APPENDIX P SPECIES CONSULTATION

Species Consultation

Subject: Request for Species Review - Sunset Ridge Solar

Subject: South Branch Solar (formerly Sunset Ridge Solar), TAILS# 03E15000-2021-TA-0887

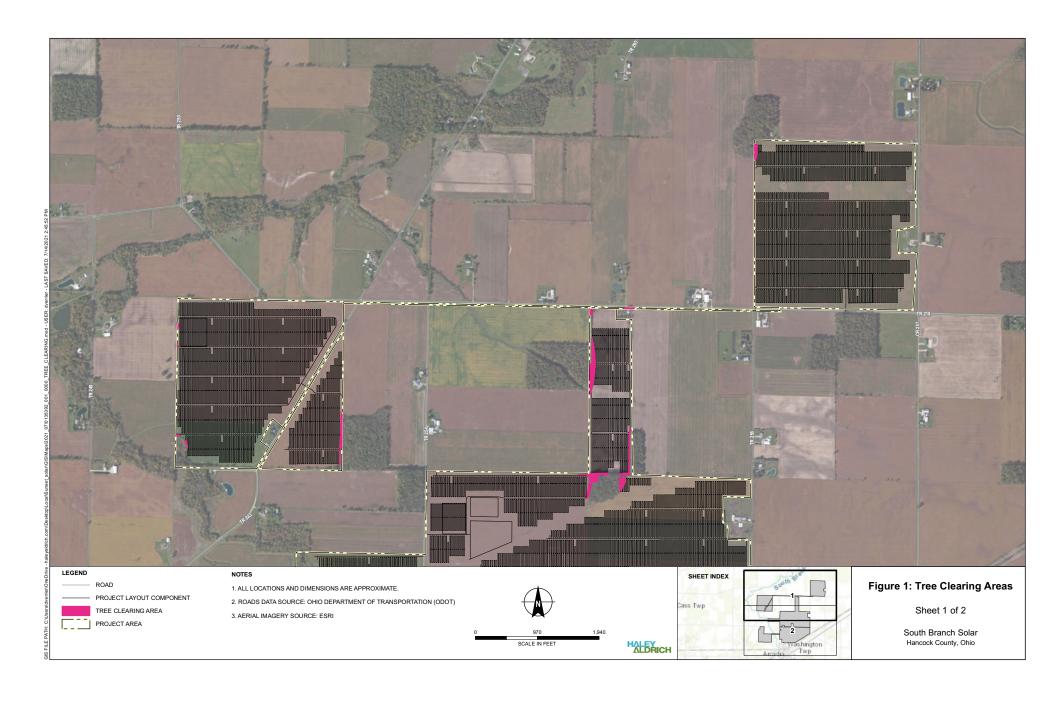
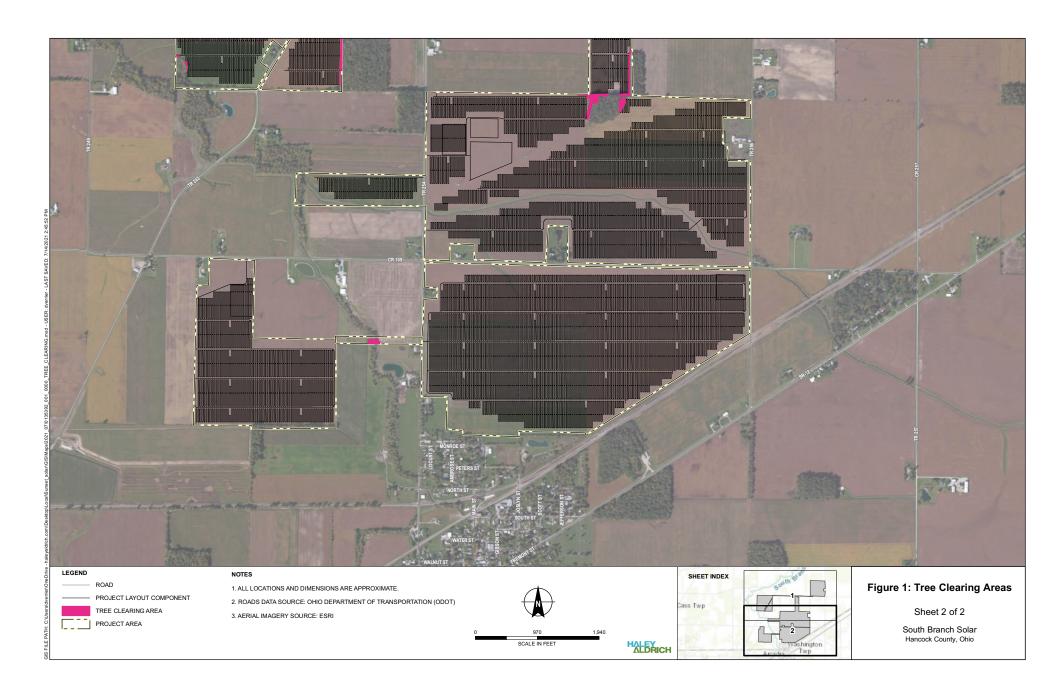
The South Branch Solar property is generally open active agricultural fields, and the proposed layout has minimized the need for tree clearing. Figure 1 shows the areas where limited tree clearing will be necessary in order to accommodate the layout and function of the South Branch Solar project. A total of approximately 4 acres of tree clearing is proposed. Clearing will be restricted to occur only between October 1 and March 31.

Thank you for the additional information. We appreciate your commitment to clear trees during the season when listed bats would not be using this habitat. If there is a federal nexus for the project (e.g., federal funding provided, federal permits required to construct), then no tree clearing should occur on any portion of the project area until consultation under section 7 of the ESA, between the Service and the federal action agency, is completed. We recommend the federal action agency submit a determination of effects to this office, relative to the Indiana bat and northern long-eared bat, for our review and concurrence. If there is no Federal nexus, then no additional coordination is necessary.

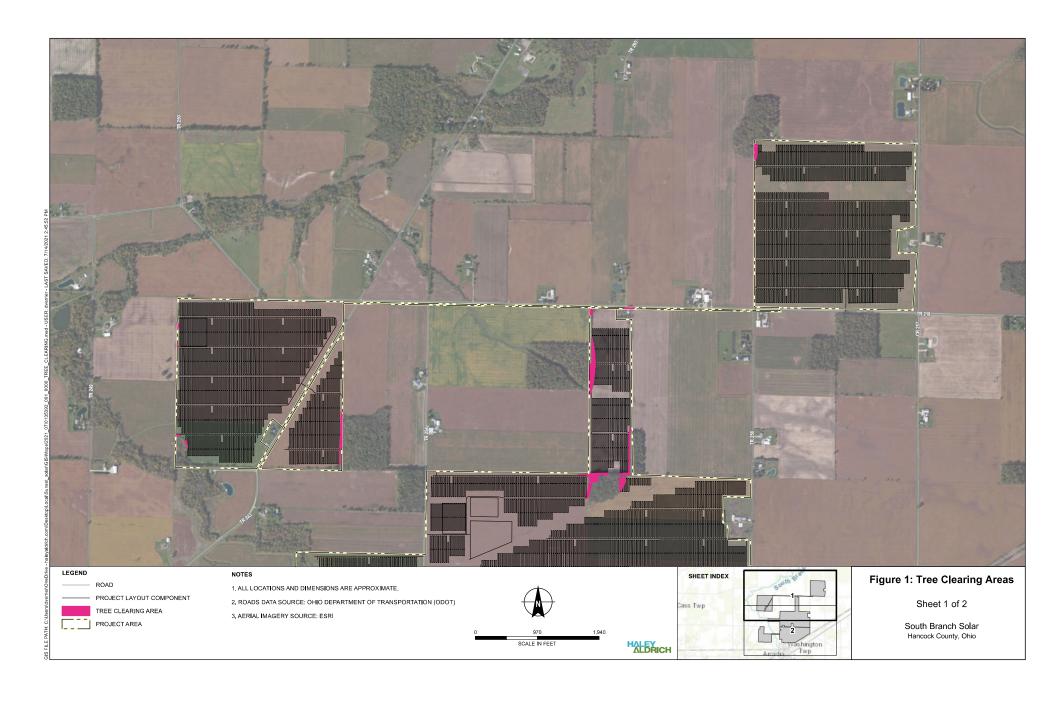
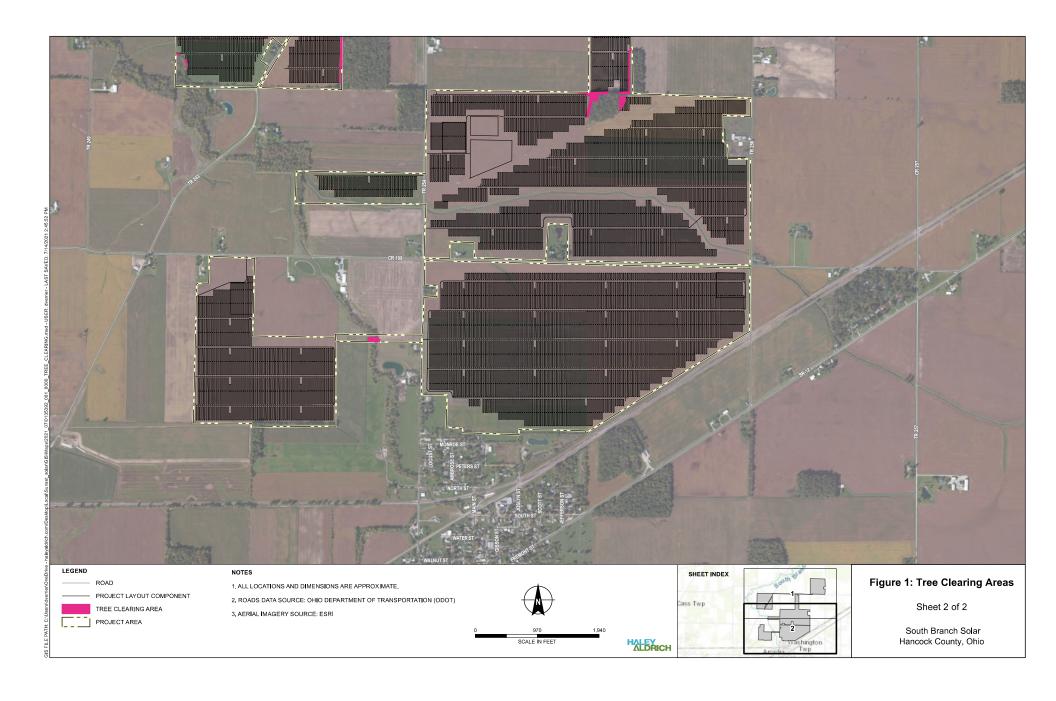
The Project property is generally open active agricultural fields, and the proposed layout has minimized the need for tree clearing. Figure 1 shows the areas where limited tree clearing will be necessary in order to accommodate the layout and function of the Project. A total of approximately 4 acres of tree clearing is proposed. Clearing of trees ≥3 inches diameter at breast height will be restricted to occur only between October 1 and March 31.

Wetlands and waterbodies delineated on-site are relatively small (as can be seen on Figure 1) and appear unlikely to provide adequate nesting habitat for this species. The minor amounts of tree clearing proposed for Project construction will occur in narrow strips along the edges of active agricultural fields. As a result, we do not anticipate any impacts to nesting black-crowned night-herons.

State-Listed Bats Clearing of trees ≥3 inches diameter at breast height will be restricted to

occur only between October 1 and March 31. The DOW concurs that by

following this guidance, impacts to state listed bats are not likely.

South Branch Portage River (H&A ID MM3)

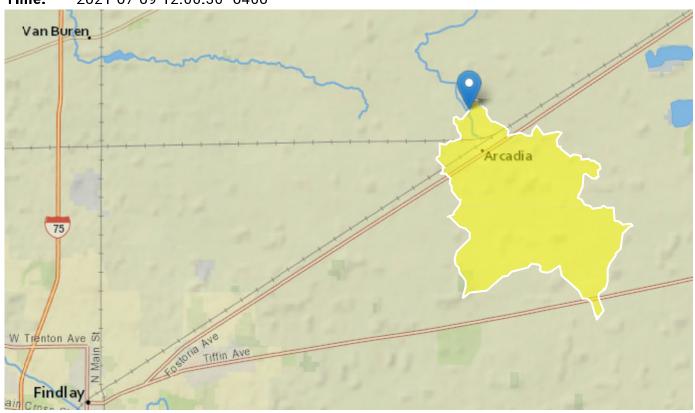
According to StreamStats (results attached) the South Branch Portage River in the vicinity of the Project site has a drainage area of approximately 7.17 square miles, while the drainage area for the unnamed stream ranges from 3.88 in the western portion of the Project site to 3.21 in the eastern portion of the Project site. A road crossing and potential collector line crossings are proposed through the perennial unnamed stream; however, based on the criteria provided by ODNR, it is our understanding that no mussel surveys would be required for in-water work proposed within the perennial unnamed stream.

Although the South Branch Portage River does have a calculated watershed greater than 5 square miles, its degraded nature may not result in suitable mussel habitat. It is expected that a below-ground collector line will be installed across this segment of the South Branch Portage River. As long as this installation does not involve in-water work, it is our understanding that a mussel survey would not be required. If in-water work were proposed, the need for a mussel survey would potentially need to be considered.

Mussels If there is no in-water work proposed in a stream with a watershed of 5

square miles or larger, there is no need for a mussel survey. If work becomes necessary, a mussel reconnaissance should be conducted in

accordance with the Ohio Mussel Survey Protocol.
